**Meeting Date:** Tuesday 10 May 2016  
**Location:** Committee Room 2, Level 5, Civic Centre, 1 Devlin Street, Ryde  
**Time:** 5.00pm

**NOTICE OF BUSINESS**

<b>Item</b>		<b>Page</b>
1	CONFIRMATION OF MINUTES - Meeting held on 12 April 2016.....	1
2	38 CONRAD STREET, NORTH RYDE. LOT 23 DP 222878. Further Report. Section 96 application (MOD2015/77) to modify development consent LDA2011/343 for alterations and additions to dwelling. ....	9
3	58 DENISTONE ROAD, DENISTONE. LOT 19 SEC 4 DP 7997. Local Development Application for demolition, construction of two storey (with attic above) new child care centre with 46 places, 11 car parking spaces, fencing and business identification signage. LDA2015/0209. ....	129

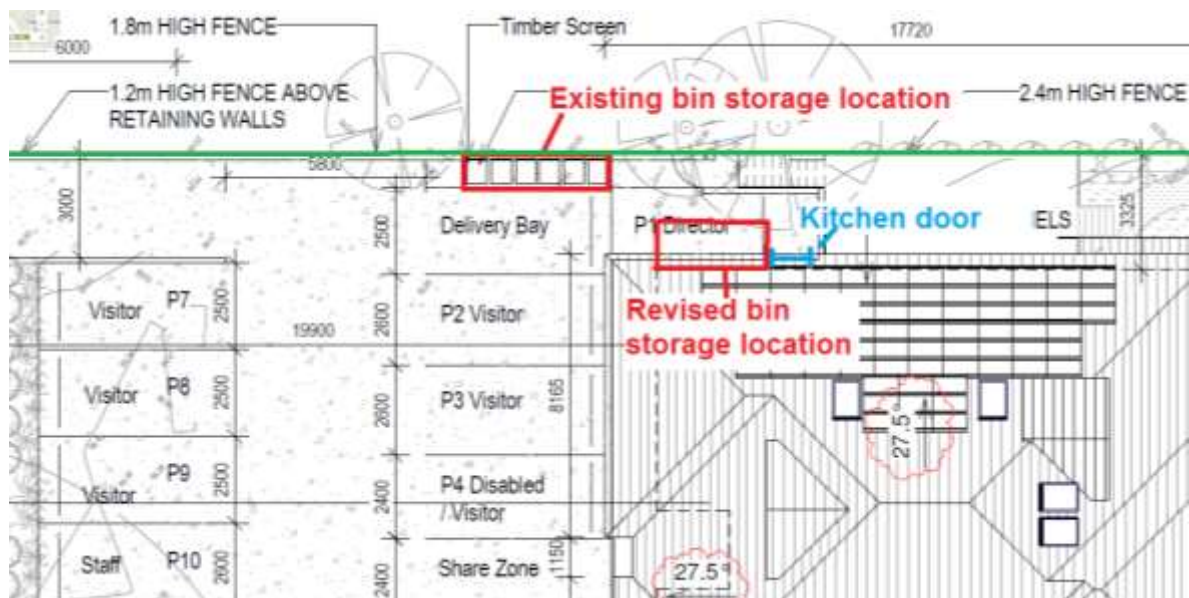
**L. Bin Storage.** *Concerns are raised that the disposal of nappies in bins along the side boundary will cause a health hazard to adjoining properties. Further, questions are raised as to where the bins will be put out for collection? Will a 'no parking' sign be provided out the front of the site so they can put their bins there?*

It is accepted that the bin storage area is situated close to the northern boundary. The Applicant's inclusion of a Director's car space is not a requirement of Part 3.2 of Ryde DCP 2014. Subsequently, the following condition of consent (condition 45) is imposed requiring the relocation of the bin storage area:
